DART AEROSPACE LTD		Work Order:	98195
Description: Crosstube Assembly, Mid Fwd		Part Number:	D206-667-147TRN
Inspection Dwg: D206-667-147 Rev: A		Page 1 of 2

DART AEROSPACE LTD HAWKESBURY, ONTARIO, CANADA	
DRAWING NO. D206-667-147	REV. A SHEET 1 OF 4
TITLE CROSSTUBE ASS'Y (206L MID FWD)	SCALE NTS
COPYRIGHT © 2010 BY DART AEROSPACE LTD THIS DOCUMENT IS PRIVATE AND CONFIDENTIAL AND IS SUPPLIED ON THE EXPRESS CONCEPTION THAT IT IS NOT TO BE USED FOR ANY PURPOSE OR CORRECTED OR OTHERWISE USED TO ANY OTHER PERSON WITHOUT WRITTEN PERMISSION FROM DART AEROSPACE LTD.

DRAWING NO. D206-667-147	TITLE CROSSTUBE ASS'Y (206L MID FWD)	REV. A	DART AEROSPACE LTD ENGINEERING ORDER		D.E.O. NO. D206-667-147-A-1	SHEET NO. SHEET 1 OF 1	SCALE NTS
DRAWN <i>q</i>	CHECKED <i>ADS</i>	MFG. APPR. <i>ADS</i>	APPROVED <i>MD</i>	DE APPR. <i>MD</i>			
DATE 11.07.15	DATE 11.07.20	DATE 11.07.21	DATE 11/07/21	DATE 11.07.21

DRAWING NO. D206-667-147	TITLE CROSSTUBE ASS'Y (206L MID FWD)	REV. A	DART AEROSPACE LTD ENGINEERING ORDER		D.E.O. NO. D206-667-147-A-2	SHEET NO. SHEET 1 OF 1	SCALE NTS
DRAWN AJS	CHECKED	MFG. APPR.	APPROVED	DE APPR.	DATE 12.08.02		
DATE 12.08.02	DATE 12.08.02	DATE 12.08.02	DATE 12.08.02	DATE 12.0

DETAIL P
BONDING STRAP INSTALLATION 2 PL

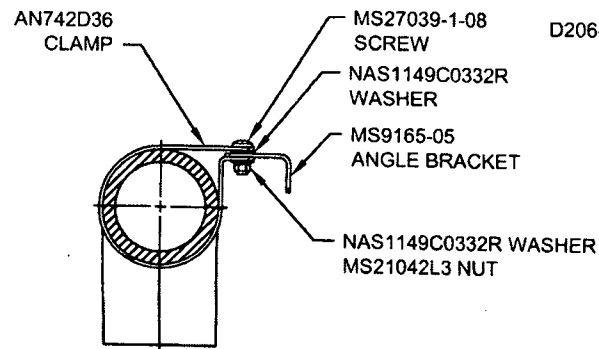
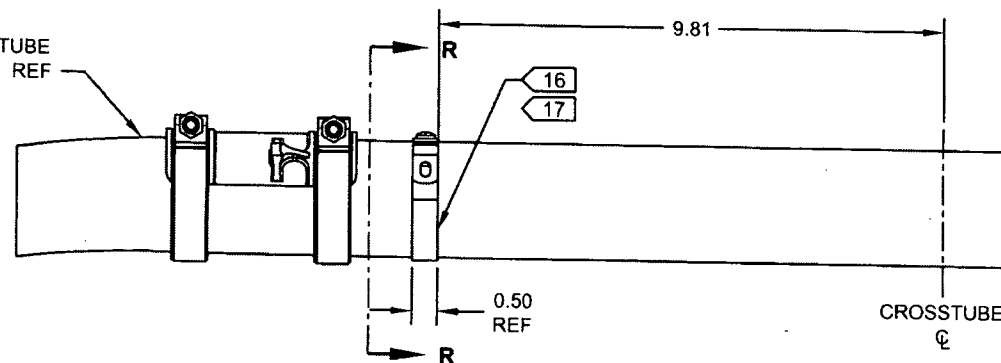
ADD ELECTRICAL GROUNDING STRAP

- 16) MASK AREA UNDER CLAMP PRIOR TO PAINTING
- 17) SEAL EDGES WHERE AN742D36 CLAMP MEETS WITH THE CROSSTUBE USING SIKAFLEX-241/-291 OR MIL-S-8802 CLASS B2 OR PROSEAL 890 SEALANT
- 18) PERFORM RESISTANCE CHECK TO ENSURE MAX RESISTANCE IS 10 MILLIOHMS
